ARC REVIEW CODE: R1902111

TO: Mayor Keisha Lance Bottoms, City of Atlanta
ATTN TO: Monique Forte, Planner III, Office of Mobility Planning
FROM: Douglas R. Hooker, Executive Director, ARC
RE: Development of Regional Impact (DRI) Review

Name of Proposal: Atlanta Dairies (DRI 2897)

Description: This DRI is on 9.78 acres in the City of Atlanta, south of Memorial Drive, east of Pearl Street, north of Old Flat Shoals Road, and west of Chester Avenue. The project consists of 564 multi-family residential units, 46,165 SF of office space, and 50,170 SF of retail space, and a 36,238 SF music venue. Site access is proposed via one driveway on Memorial Drive, one driveway on Pearl Street, and two driveways on Old Flat Shoals Road. The estimated buildout year is 2021. An initial phase of the development is under construction, and the local trigger for this review is a Special Administrative Permit (SAP) application for the second residential phase (which moved the development past the DRI threshold).

TITLE
DRI SITE PLAN

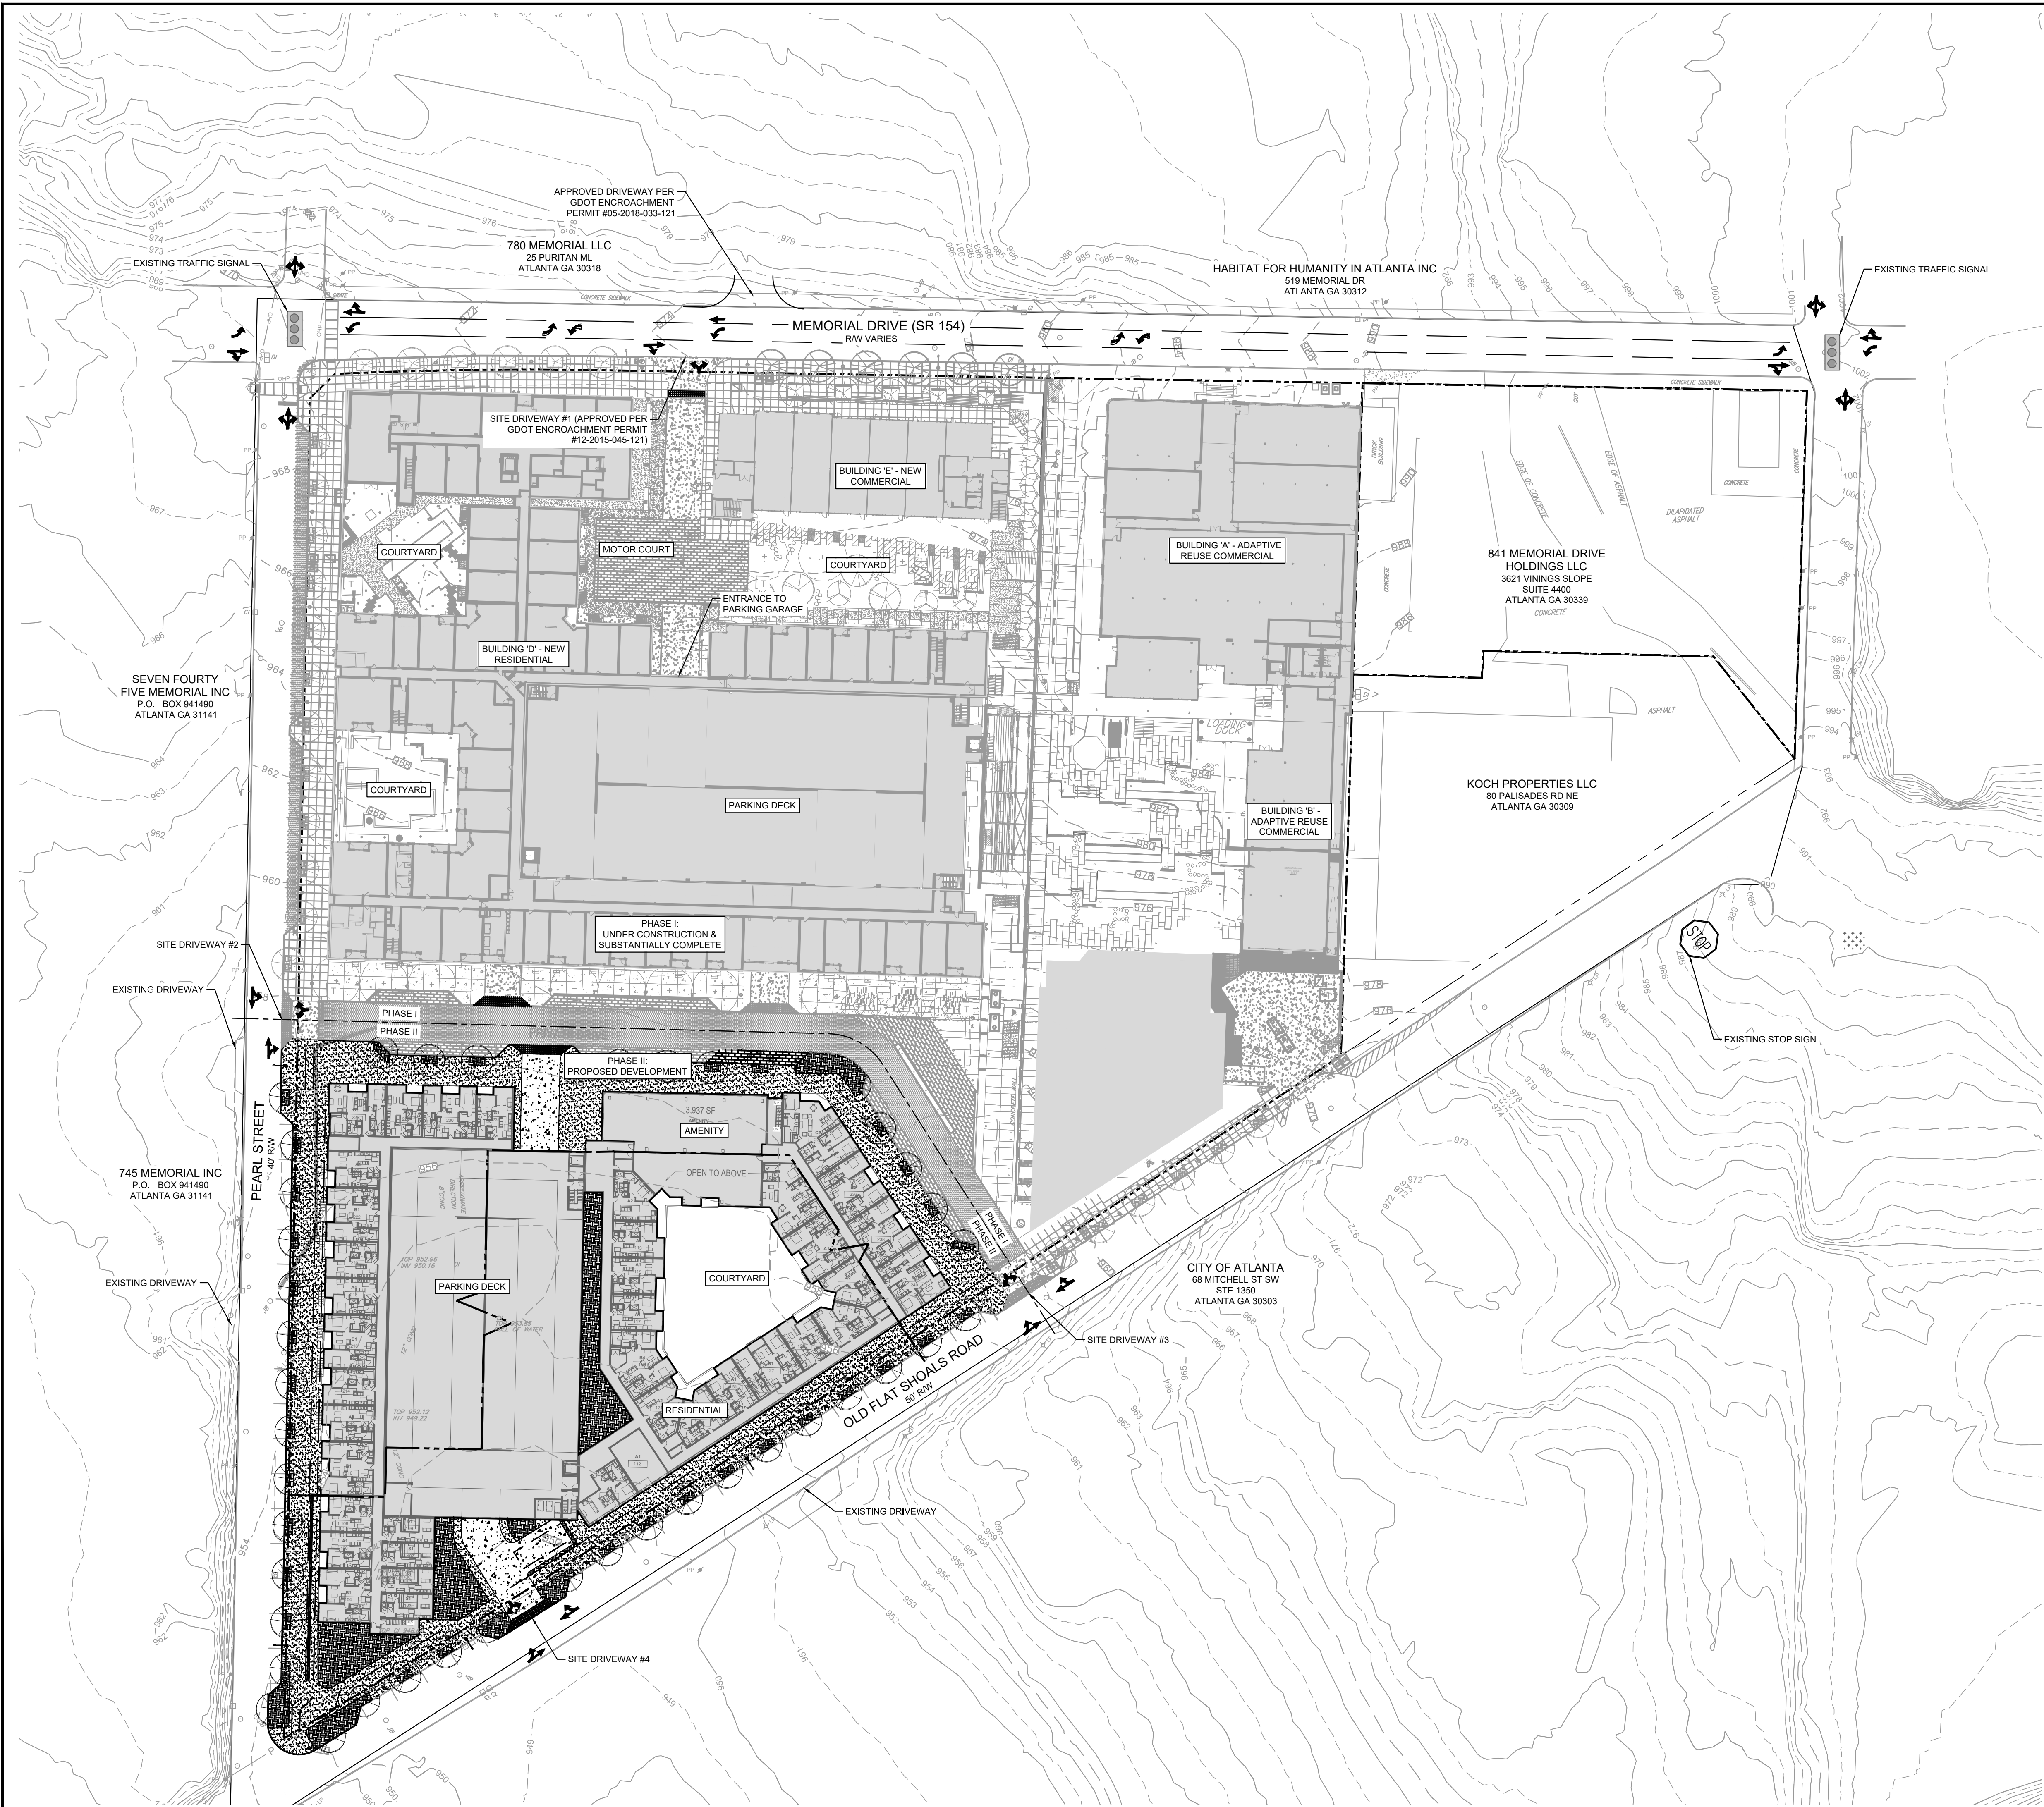
The intensity of this proposed project generally aligns with the RDG's recommended parameters regarding density and building height in Maturing Neighborhoods. It should be noted that the submitted site plan indicates building heights of up to 7 stories but does not specify heights for each building on the plan. This information would be helpful for all parties to understand as the City's review moves forward – specifically for Phase II which is not yet under construction, unlike Phase I which is substantially complete. In general, ARC recommends that the tallest structures be placed toward the rear (south side) of the site, closer to I-20, so that the structures fronting Memorial Drive are in keeping with the character of nearby properties in the corridor. The land use mix is generally consistent with the RDG, specifically in terms of promoting mixed-use in areas close to existing or planned transit. The RDG also recommends ensuring that new and infill development is compatible with existing neighborhoods. City leadership and staff, along with the development team, should therefore collaborate to ensure maximum sensitivity to nearby neighborhoods, land uses, structures and natural resources.

The development proposes four unsignalized full movement access points for the development: One on Memorial Drive one on Pearl Street and Two on Old Flat Shoals Road. Memorial Drive (SR 154) is a regional thoroughfare.

The development proposes pedestrian facilities internal to the site. Existing facilities along adjacent roadways provide pedestrian connections to adjacent sites.
